TO: Bob Benedict  
FROM: J Costello/R Prados  
SUBJECT: WATERFORD SES UNIT NO. 3  
REPLY TO NRC CONCERN OVER THE EFFECT OF  
CLOUD EXPANSION UPON BURNING

## REPLY TO NRC CONCERN OVER THE EFFECT OF CLOUD EXPANSION UPON BURNING

Figure 1

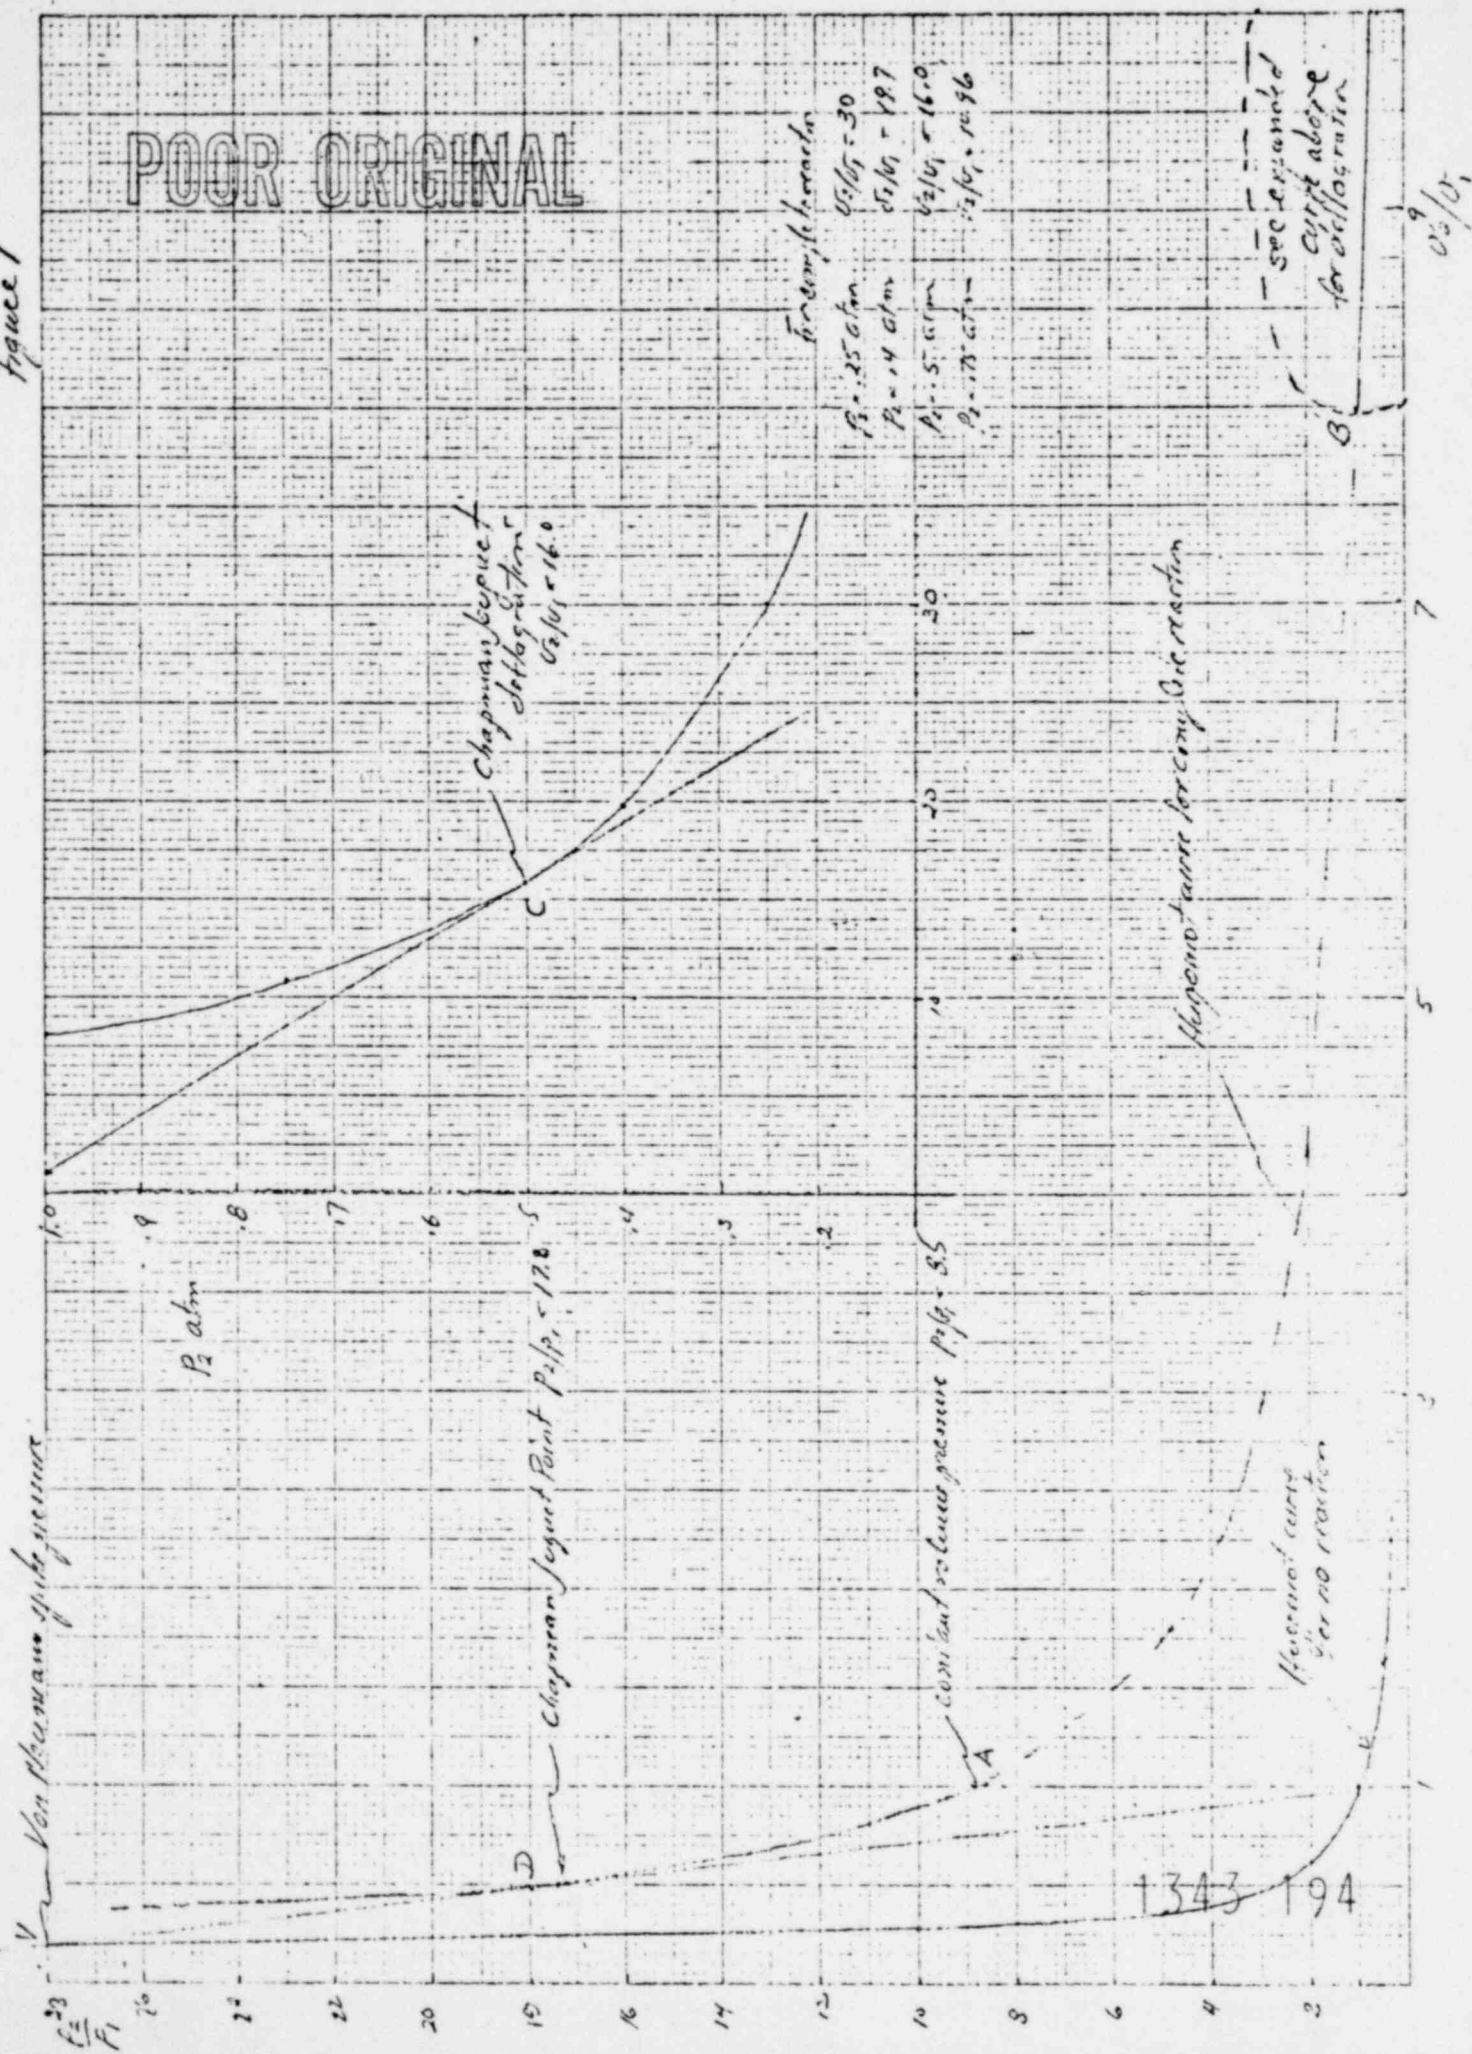
Figure 1 shows both Hugoniot curves. The Hugoniot curve for the complete reaction is distinguished by two branches. The branch from A to V is the "detonation" branch and the one from B to C is the "deflagration" branch. It has been shown that the only possible stable detonation is the detonation proceeding at the minimum detonation velocity (see reference 1). This is the Chapman-Jouguet detonation and the resulting detonation overpressure can be found by running a tangent line to the detonation branch from the original condition. The resulting C-J overpressure for stoichiometric propane air mixture has been determined to be  $p_2/p_1 = 17.8$  from an initial state of 14.7 psi and 460°F.

That value is closely correspondent to that reported by J. H. Lee and others (reference 2 and 3). Point A corresponds to the overpressure resulting from an adiabatic constant volume explosion. The value obtained of  $p_2/p_1 = 8.7$  differs slightly from that quoted in various references including reference 2, which reports 8.34. The difference is due essentially to the initial state assumed for these calculations which was 0°C, whereas others generally used 25°C.

The intersection of the tangent line with the Hugoniot curve for no reaction is the Von Neumann spike which precedes the C-J detonation pressure. Its computed value is approximately  $p_2/p_1=28$ , again in close agreement with values reported in the literature.

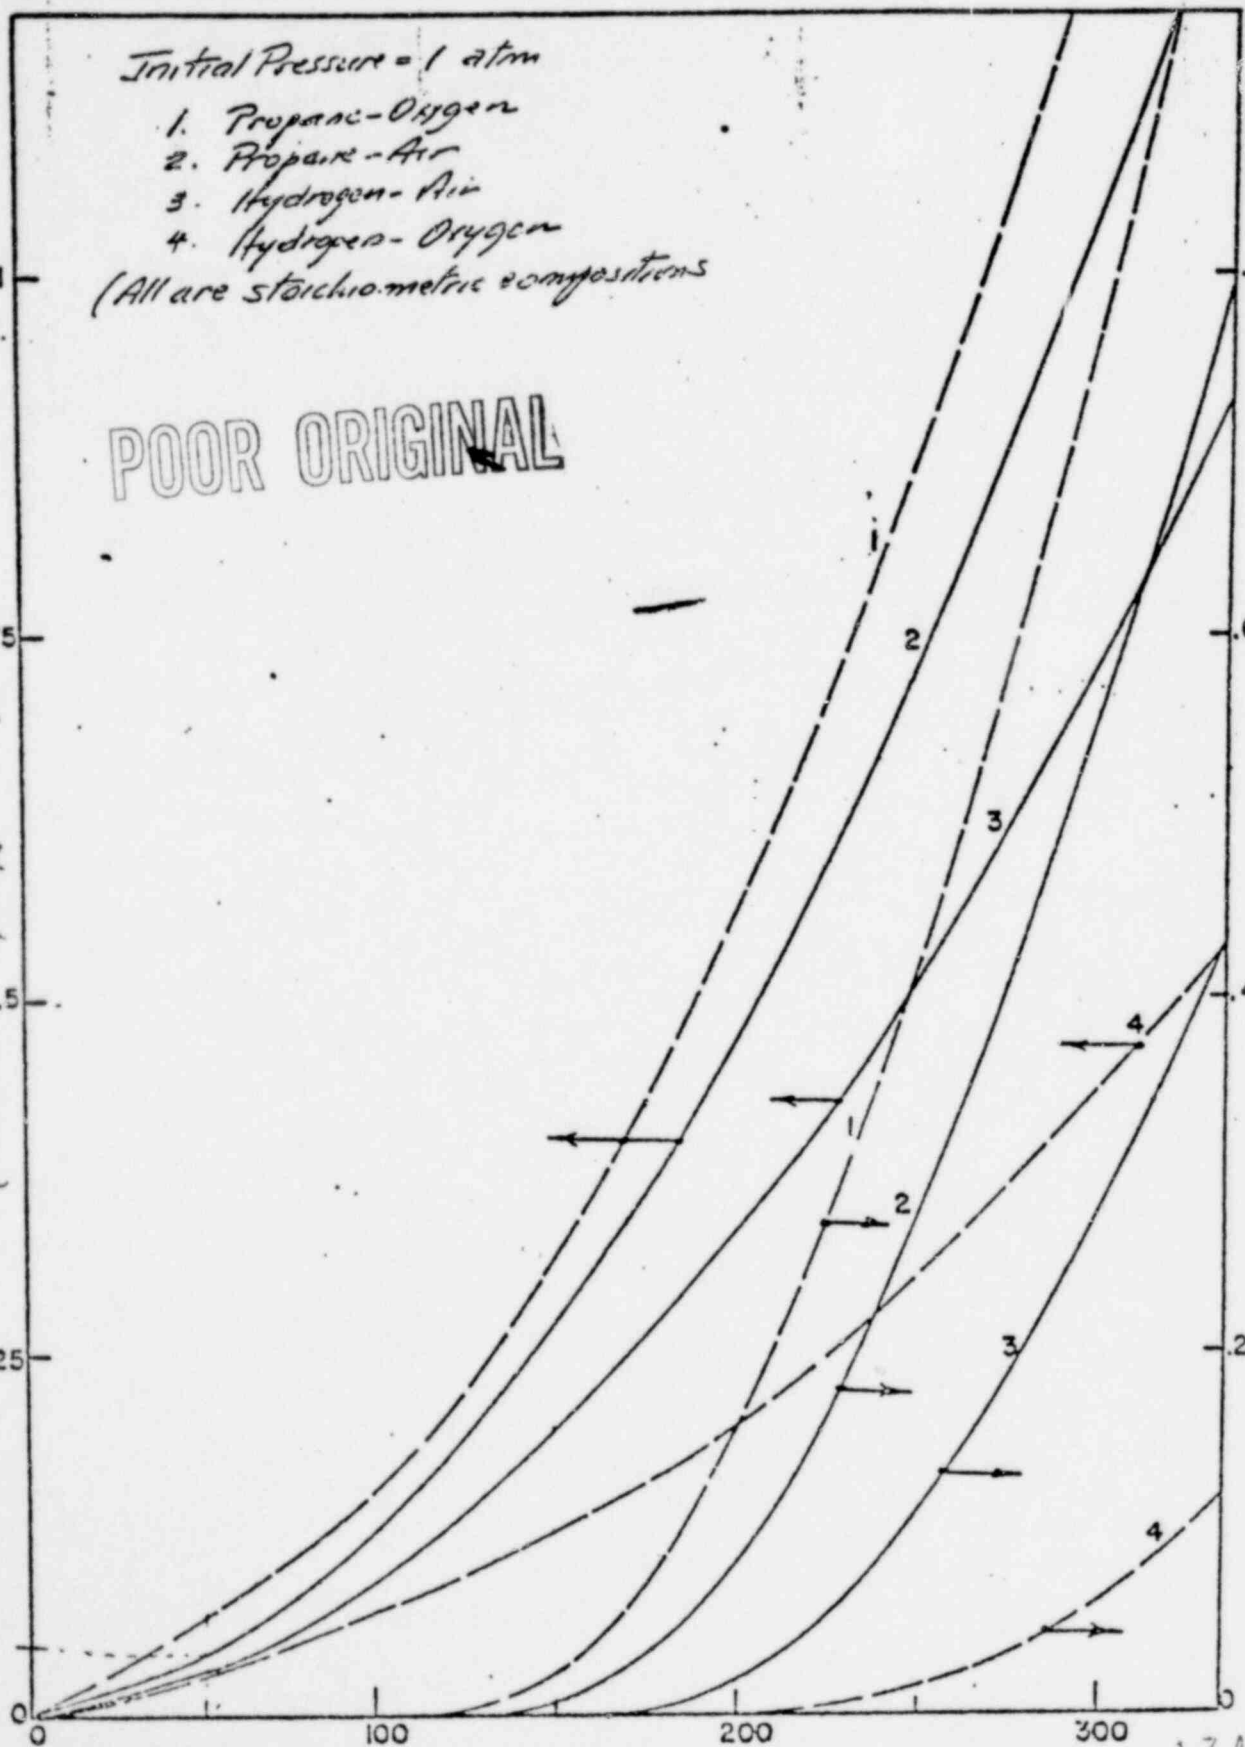
For these kinds of deflagrations, the precompression sent into the unburned medium and surrounding air is in the nature of basically an acoustic wave, which does not steepen into an air shock unless spatial flame velocities of 300 fps or more are achieved, as shown in the attached figure taken from reference 1.

Likewise there is no overpressure of great significance within the deflagrating cloud. For typical spatial burning velocities of 30 fps or less, overpressures of about 1 psi will occur just ahead of the flame front. Hence it is concluded that blast damages are insignificant for deflagrative burning of propane air clouds either near or far from the cloud. Hence for a deflagration the possible damage is limited to temperature.

Fig. 4—Lateral diffusion,  $\sigma_y$ , versus downwind distance from source for Pasquill's turbulence types (Source: Ref. 25)

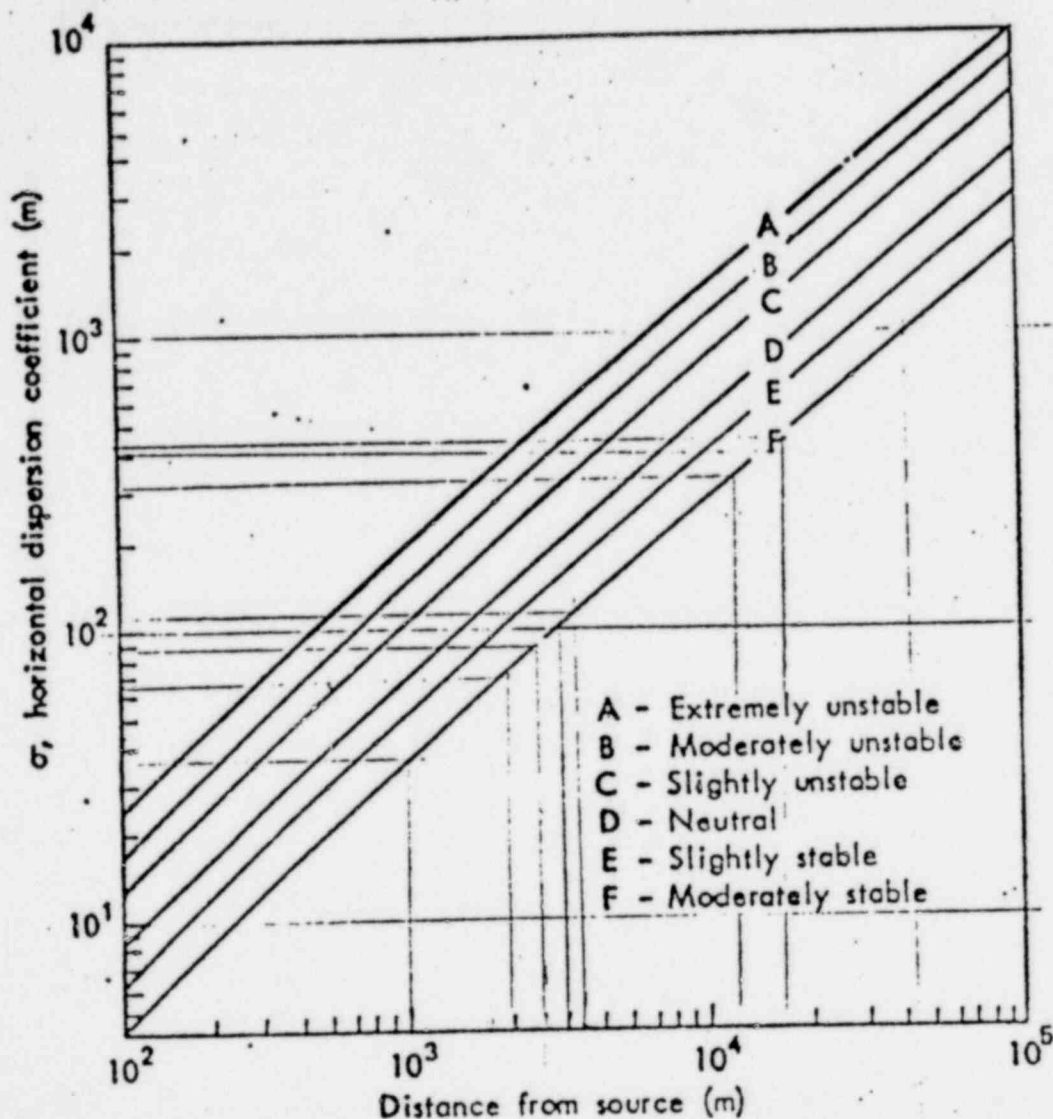
In addition an overconservatism was discovered in the values of  $\sigma_y$  and  $\sigma_z$  used in assembling the information of Figure 2.2-9. Smaller values of  $\sigma_y$  has been used than published in the literature for distances downwind exceeding 2500 ft.

With the corrected Table 2.2-21 and Figure 2.2-9, the lower limits of flammability and detonability are reached at 5020 and 4298 ft respectively. Similarly the upper and lower detonability limits are reached at 2178 ft and 2575 ft from the break.
